UNITED STATES PATENT AND TRADEMARK OFFICE

Office Action Summary

10/721,575

REX W. BEASLEY

2,823,425

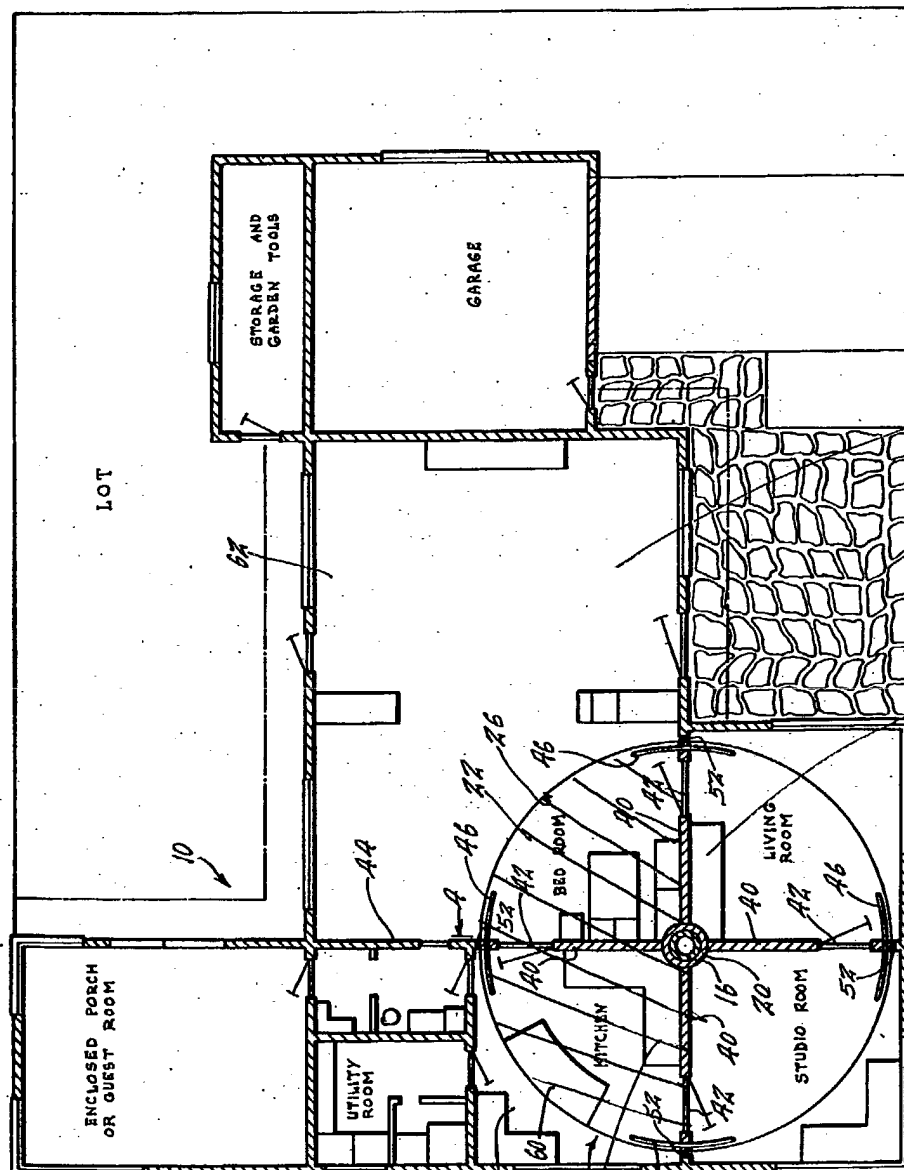
Claim 35 is rejected under 35 U.S.C. 102(b) as being anticipated by US Patent #2,832,425 to GRANEK. GRANEK discloses a movable wall module for installation into an opening formed in a wall (44) of a building wherein the building wall (44) separates first (hatch lined) and second spaces each including a stationary floor (F) disposed respectively at opposite sides of the building wall (44), said movable wall module comprising:

a generally upright module frame (25,40) having generally vertically extending first and second sides; first component means (FC) supported on said first side (hatch lined) of said frame (25,40); second component means (SC) supported on said second side of said frame (25,40); and means (32,38) for movably supporting said frame (25,40) within the building wall opening for movement between a first position with said first and second (FC,SC) component means presented respectively to said first (hatch lined) and second spaces, and a second position with said first and second component means (FC,SC) presented respectively to said second and first spaces (hatch lined), and further wherein the stationary floor area (F) within said first (hatch lined) and second spaces is substantially exposed and unobstructed by said frame (25,40), when said frame (25,40) is in either one of said first (hatch lined) and second positions, see the marked attachment.

a module frame(25,40) having a first side (hatch lined) and a second side; first component means (FC) supported on said first side of said frame (25,40) ; second component means (SC) supported on said second side of said frame (25,40); and means (26,28,30,34,36) for movably supporting said frame(25,40) within the building wall opening for selectively and reversibly presenting said first and second

component means (FC,SC) respectively within rooms or spaces disposed at opposite sides of the building wall (44); and further including castor means (32,38), column 2, lines 31-53, for supplemental rolling support of said second component mans (SC) upon movement of said frame (25,40), see the marked attachment.
